# CONSTRUCTION AUTHORIZATION FOR AN ON-SITE WASTEWATER TREATMENT & DISPOSAL SYSTEM

# IMPROVEMENT PERMIT for a RESIDENTIAL ON-SITE WASTEWATER TREATMENT & DISPOSAL SYSTEM

# SEPTIC SYSTEM DESIGN REVIEW WORKSHEET

# Residential Subsurface Wastewater Treatment and Disposal System Design

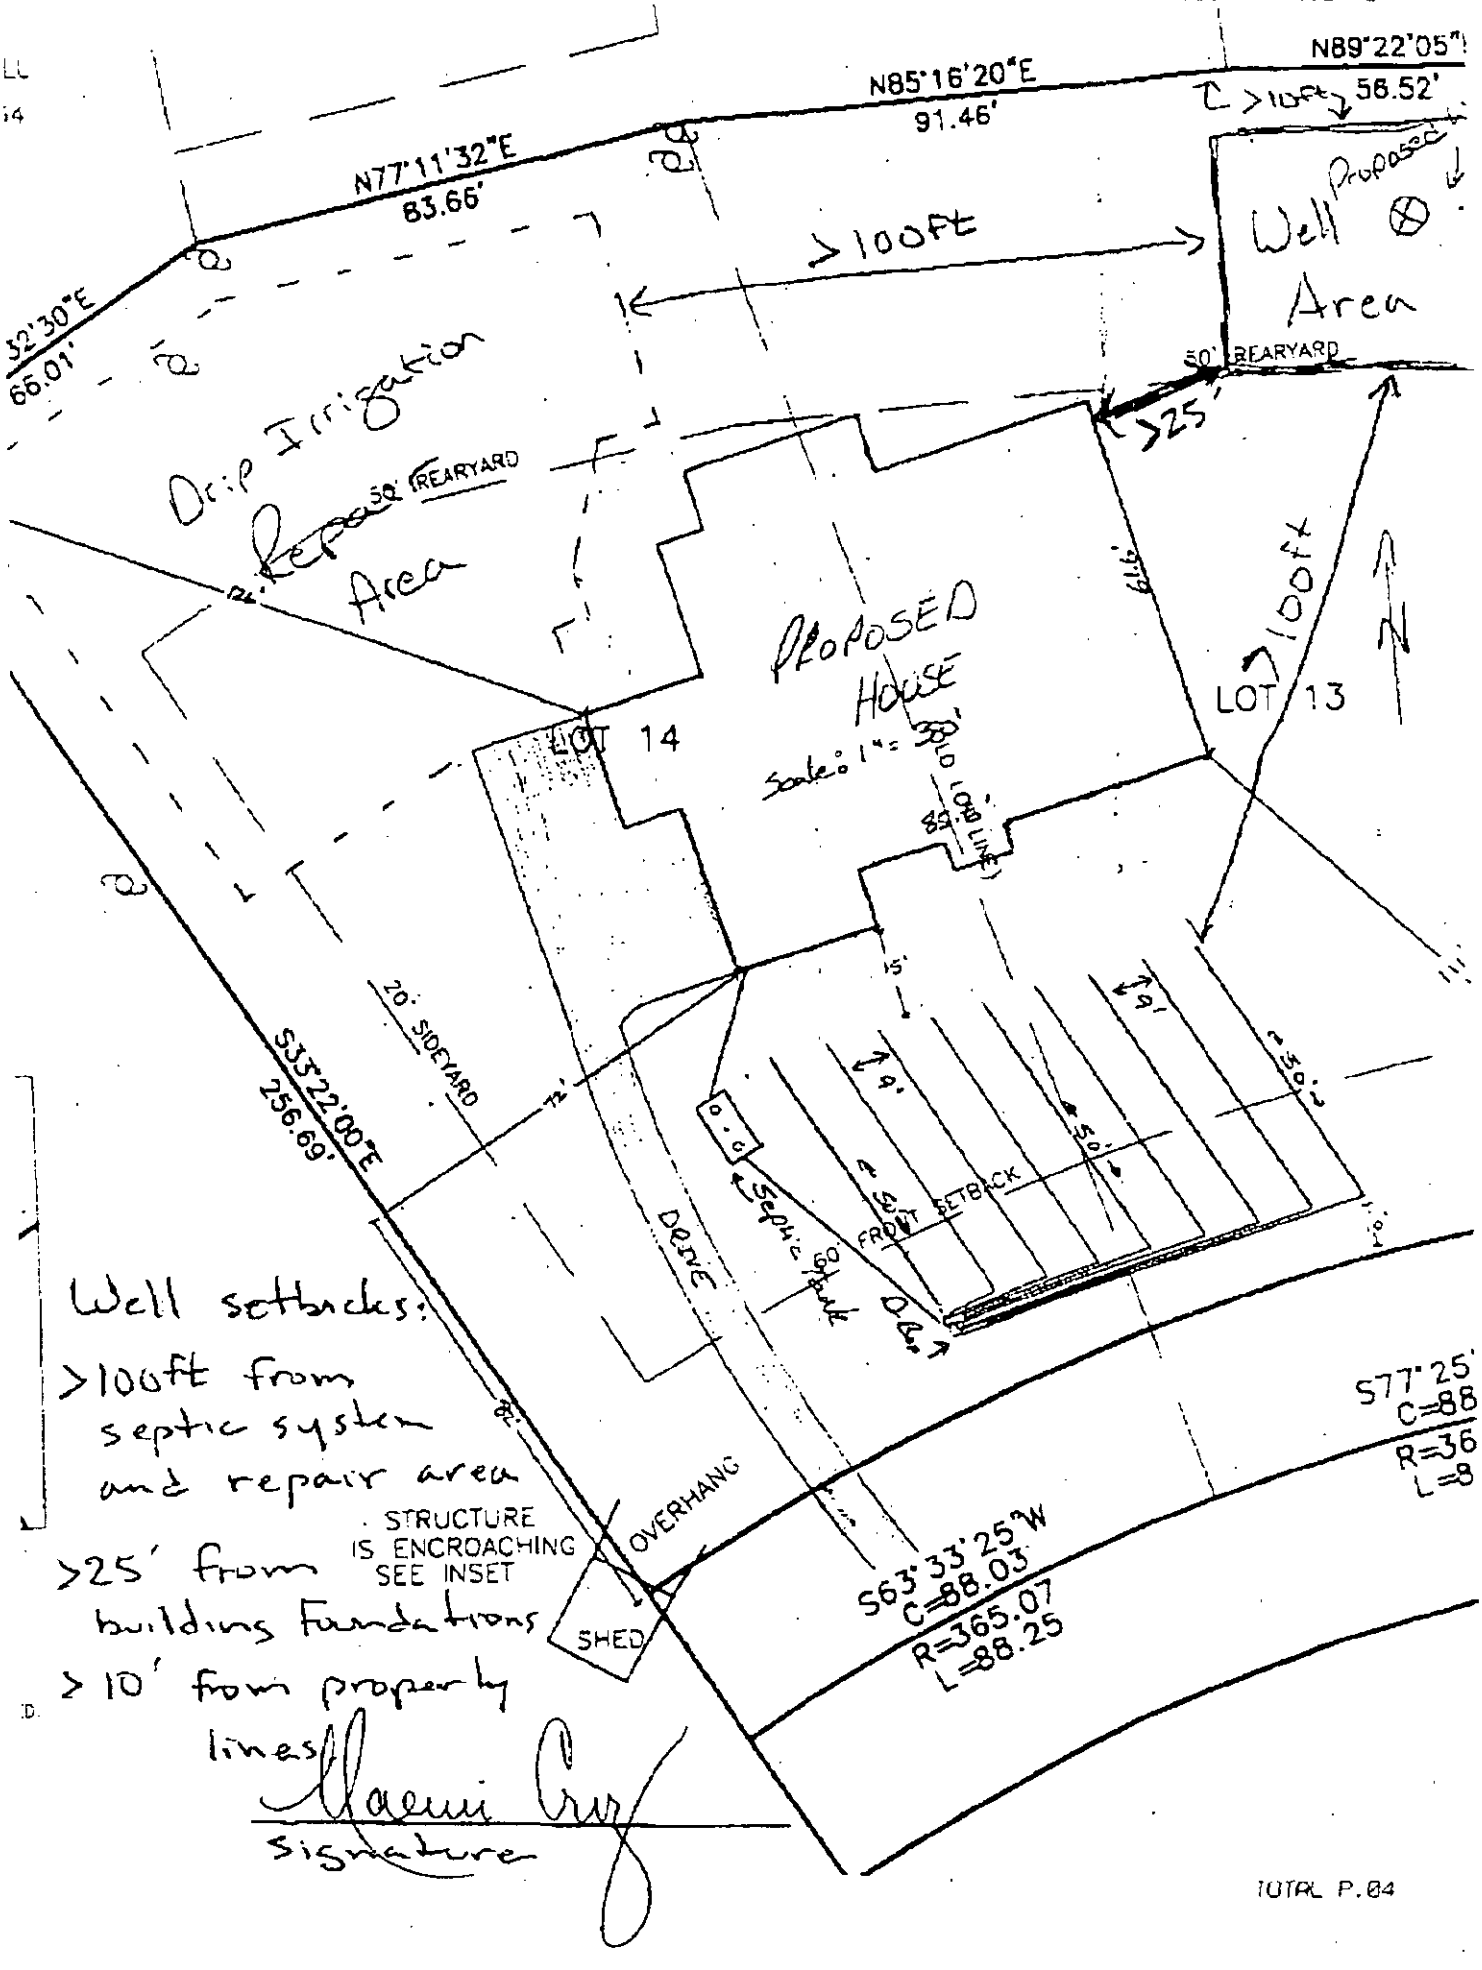
- Additional soil cover, as specified on the plot plan, required over the drain field must be inspected and approved prior to issuance of an Operation Permit.
- This Improvement Permit is being issued based on a supplemental soil investigation performed by staff from our office.
- The septic system shall be installed in accordance with the plans submitted by the wastewater system design consultant.
- All components of the septic system must be installed in accordance with the required setbacks listed on the corresponding plot plan.
- All components of the septic system must be located at least 100 ft. (50 ft. minimum) from all private wells.
- Install according to plans on file submitted by Larry Thompson and The Catena Group,7/3/07.

Well setbacks:

>100ft from septic system and repair area

>25' from building foundations

> 10' from property lines
